**Meeting of the Central Valley Flood Protection Board
September 28, 2012
Staff Report – Encroachment Permit
Burlington Northern Santa Fe Railroad
Lone Tree Creek Railroad Bridge Replacement, San Joaquin County**

To consider Board approval of Permit No. 18768.

The applicant proposes to replace the existing 70 foot long timber BNSF Railroad Bridge No. 1104.6 over Lone Tree Creek with a new 83 foot long by 20 foot wide flat-slab concrete bridge. The proposed bridge will only have three sets of piles in Lone Tree Creek as compared to four sets of piles for the existing bridge. New concrete abutments are also proposed at each end of the new bridge. Also proposed is rip rap along the creek bed and slopes for erosion protection 20 feet north and south of the bridge, along with rip rap protection underneath the new bridge (See Attachment B for general and pile plans for the new bridge).

SHEET NO.
Attachment D, Figure 4
SHEET 1 OF 2

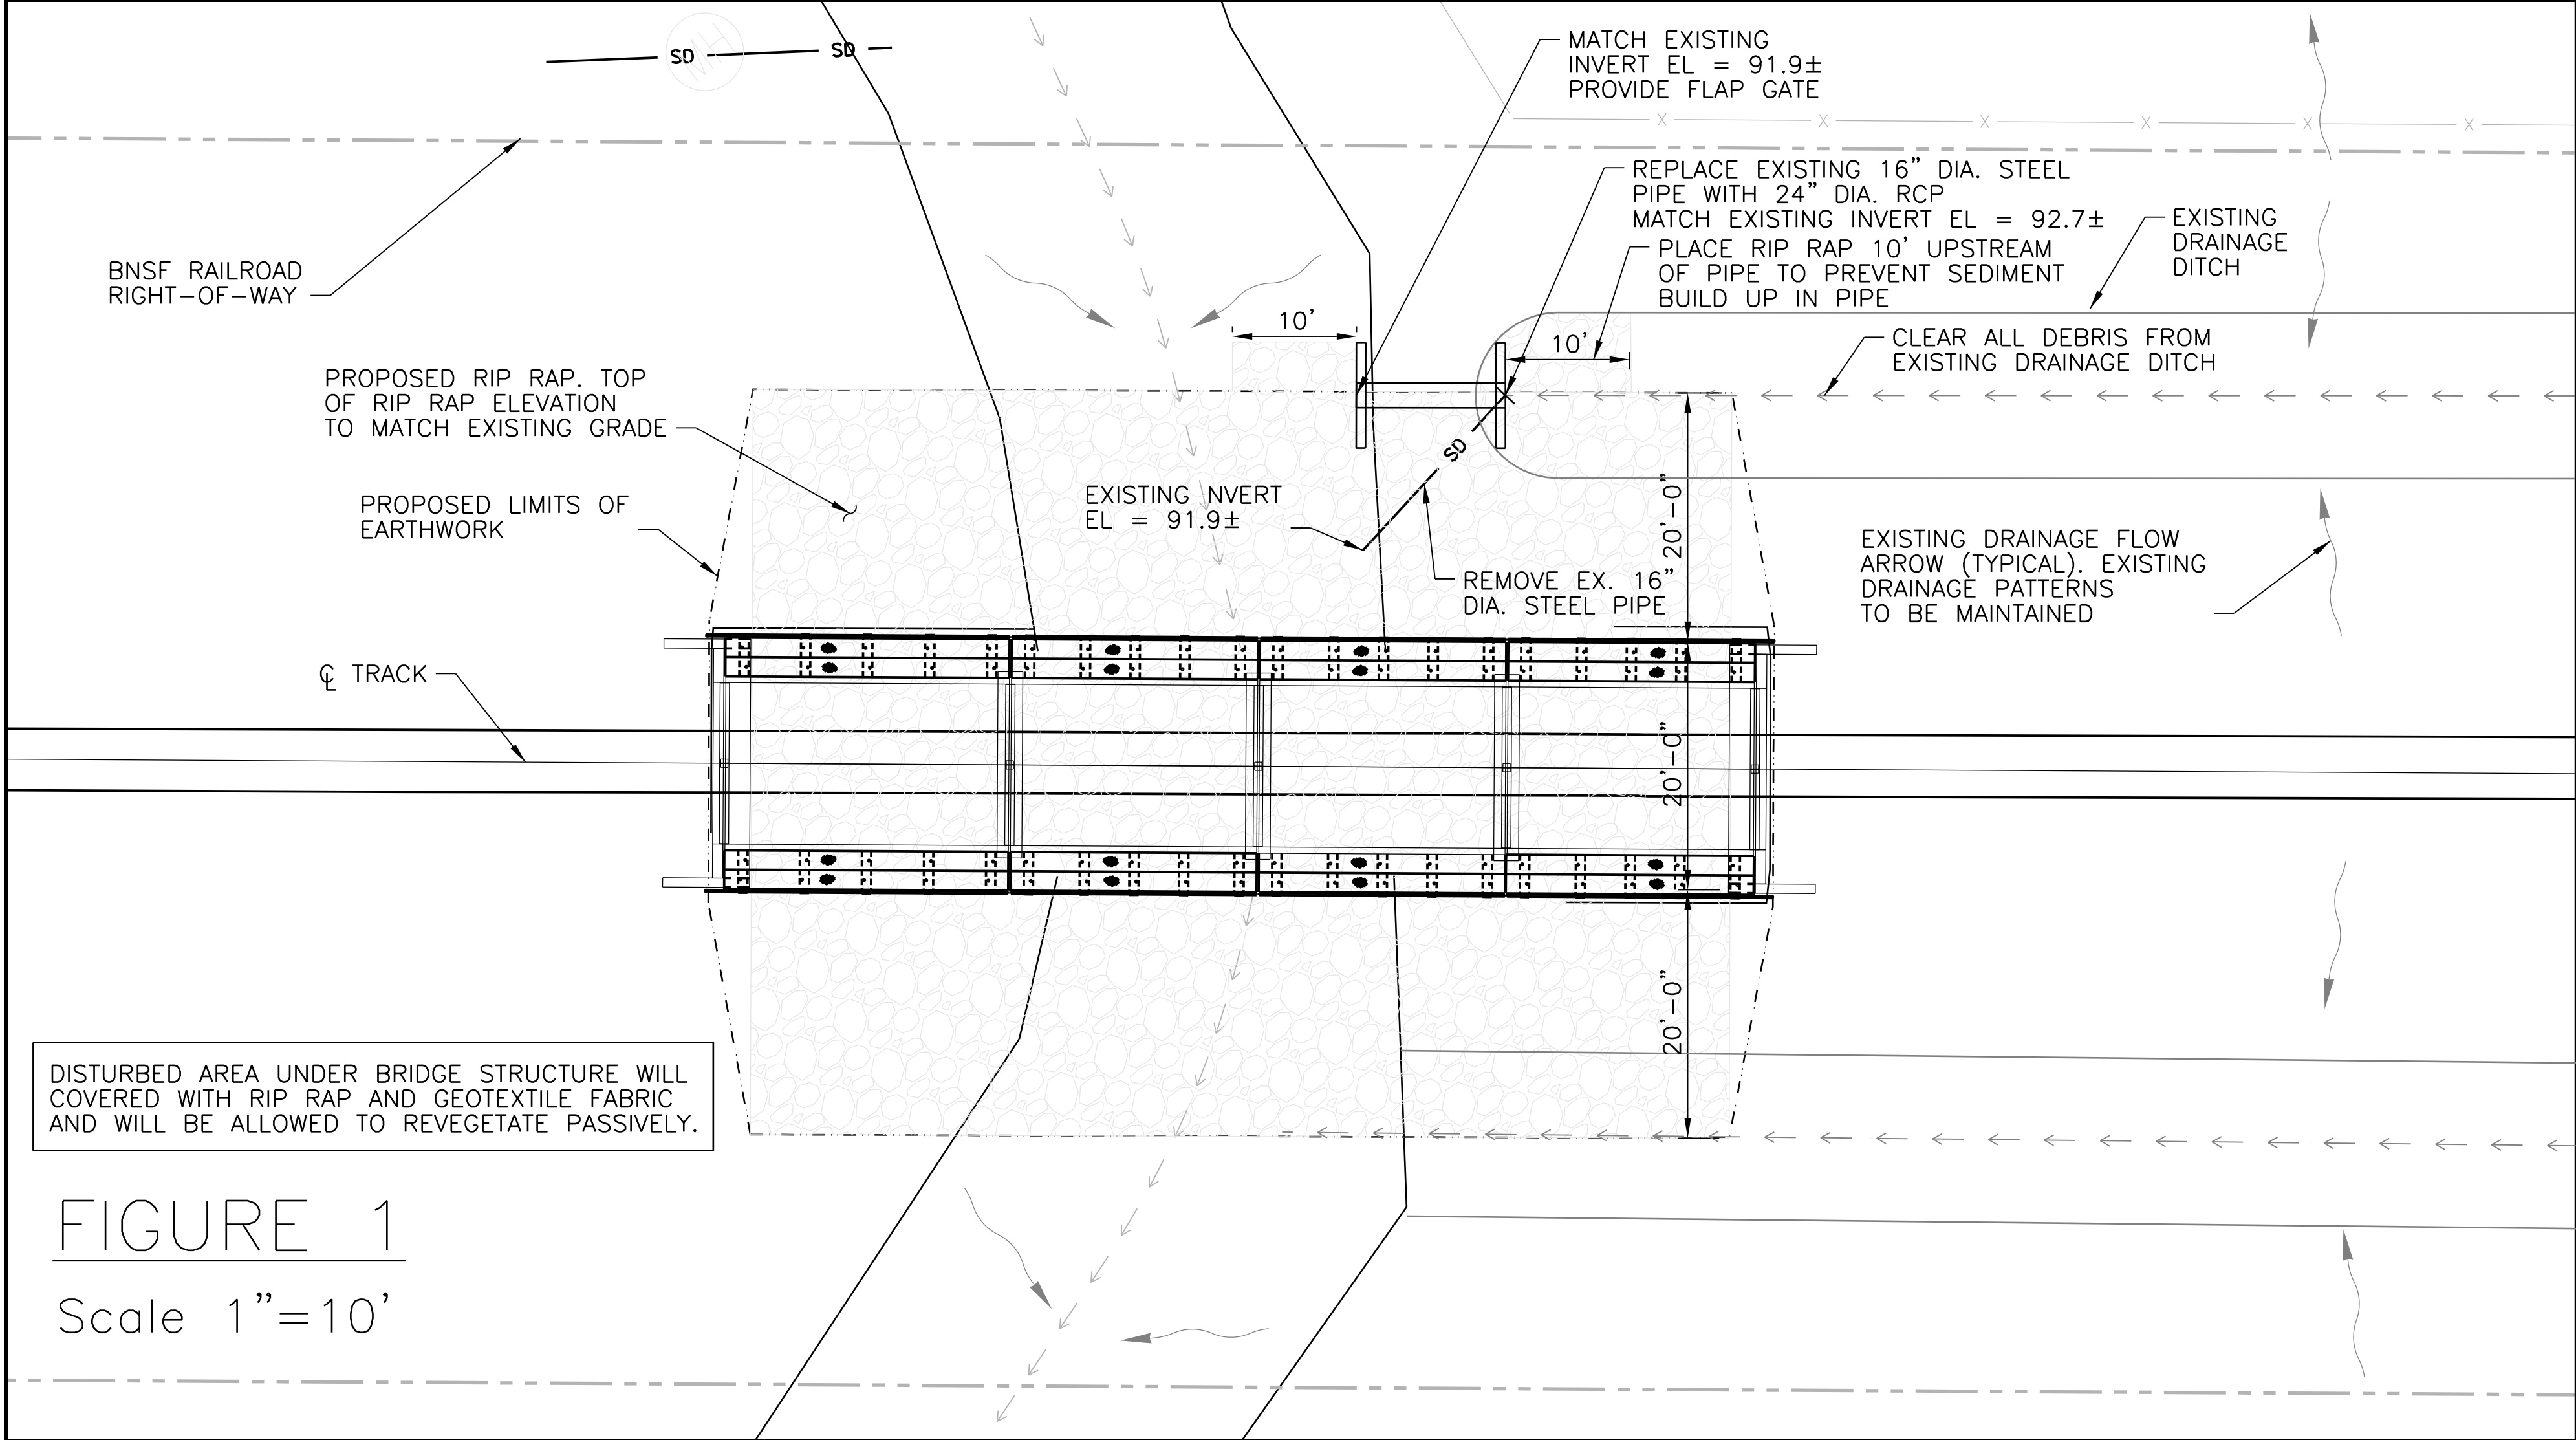
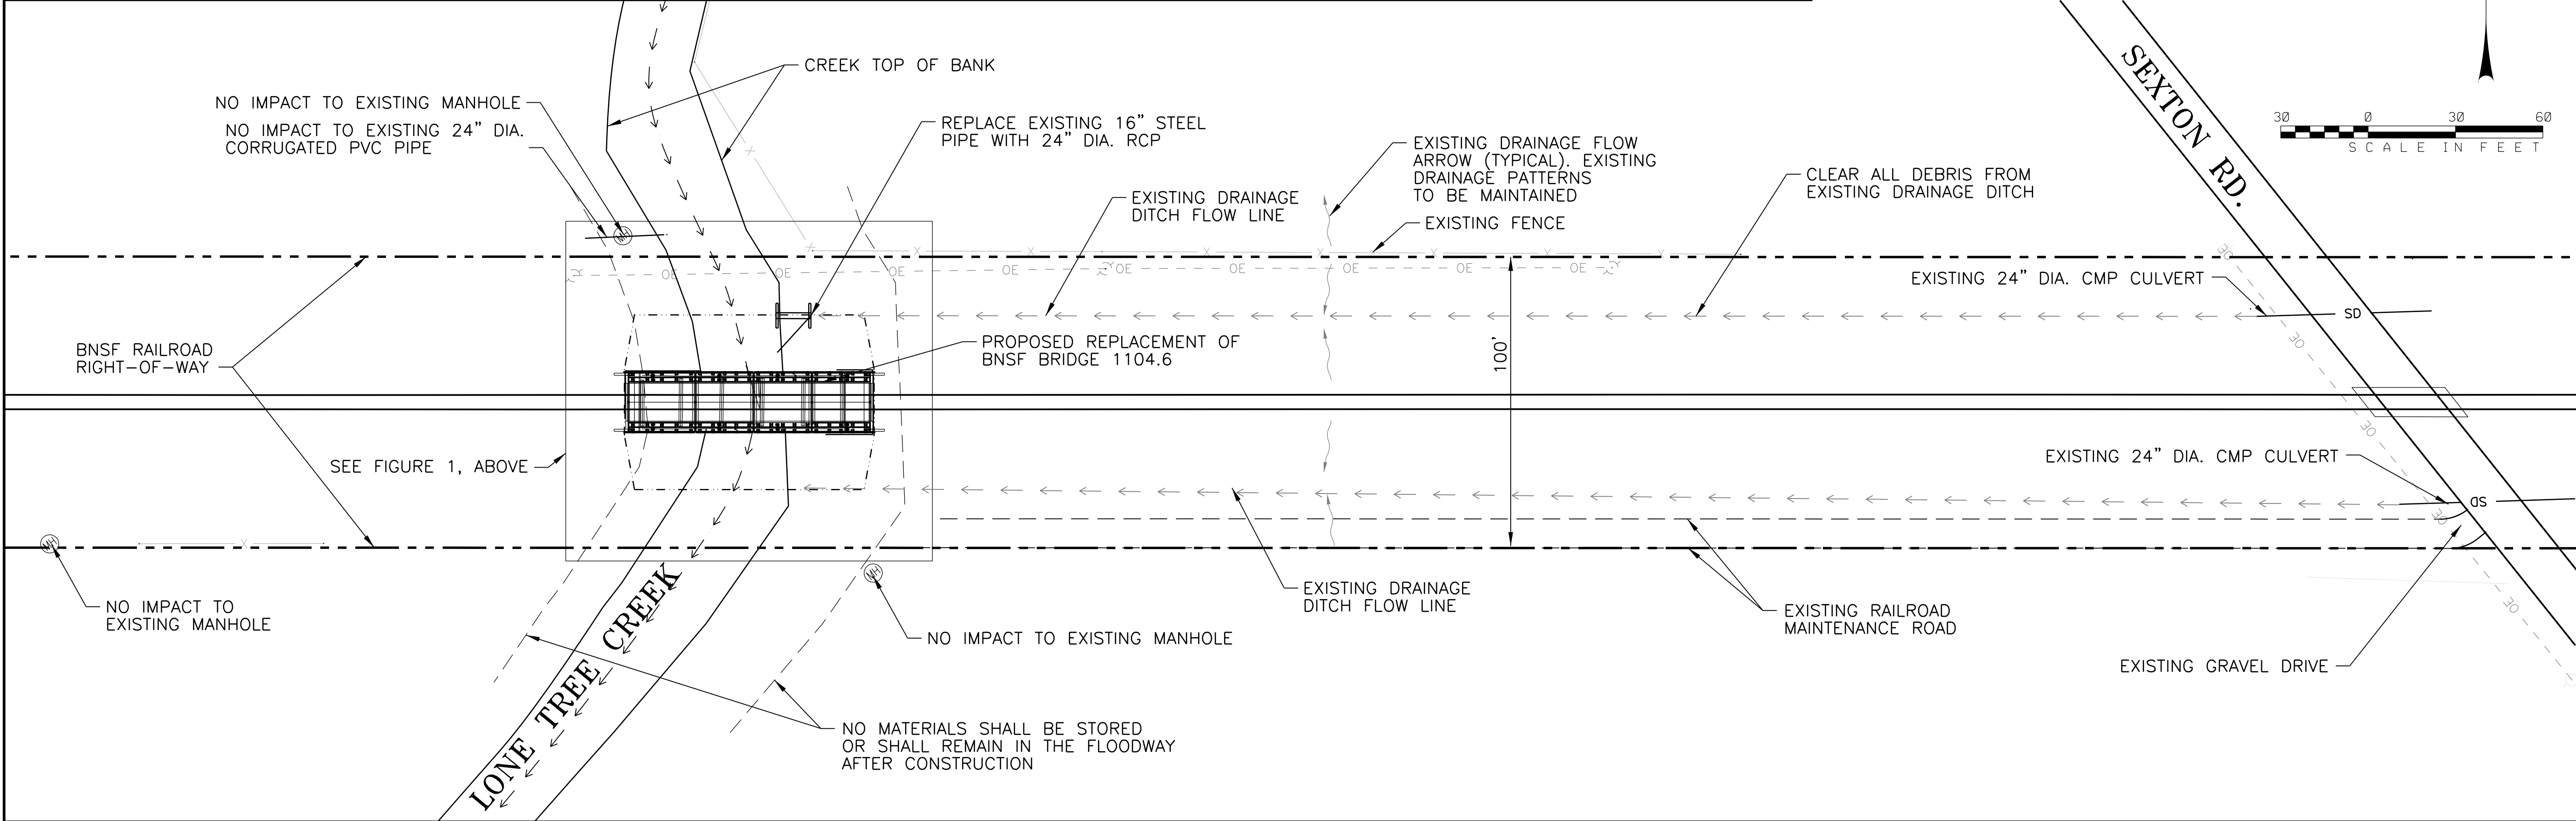
The attached detailed drainage plan from BNSF proposes to replace the existing 16-inch steel drainage pipe with a new 24-inch reinforced concrete pipe that includes headwalls and a flap gate on the downstream end, along with rip-rap placed within 10 feet of both ends of the pipe to help prevent vegetation growth and erosion. The drainage plan also notes the cleaning of the drainage ditch north of the railroad tracks of debris to prevent future clogging of the new 24-inch pipe. CVFPB staff will be recommending this detailed drainage plan become part of the construction plans for the replacement of this railroad bridge over Lone Tree Creek, and also be a part of the applicant's encroachment permit.
